TELEPRINTER No.3 W, X, Y AND Z.

SCHEMATIC CONNECTIONS.

TG(L)1031A. 6 · 4 · 36

TG(L) 1031
2 PANELS-1

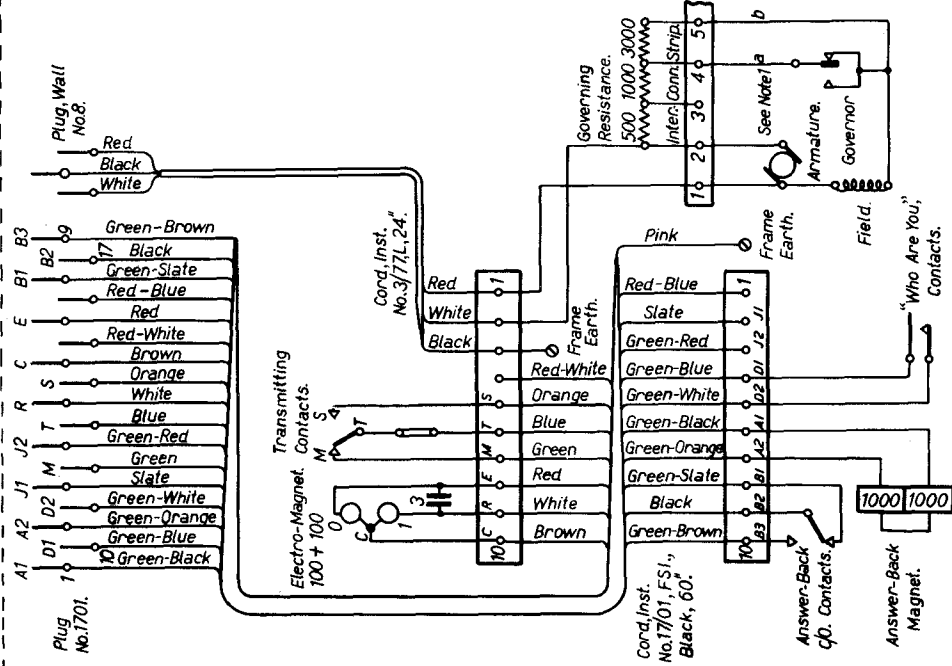
CIRCULATION	
	GEN.	
	Suffix	
	4-5-37 A	
	29-1-48 B	
	2-4-49 C	
LL No. WAS C1009. W.C.P. C.O.L. A.G.B. (REDRAWN & CORRECTED PAPER FAIL CONTACTS ADDED 29-1-48 B) (REDRAWN, PLUG 1701 WRONGLY NUMBERED; NOTE I ALTERED 2-4-49 C)		
Amendt.		
PAPER		
W
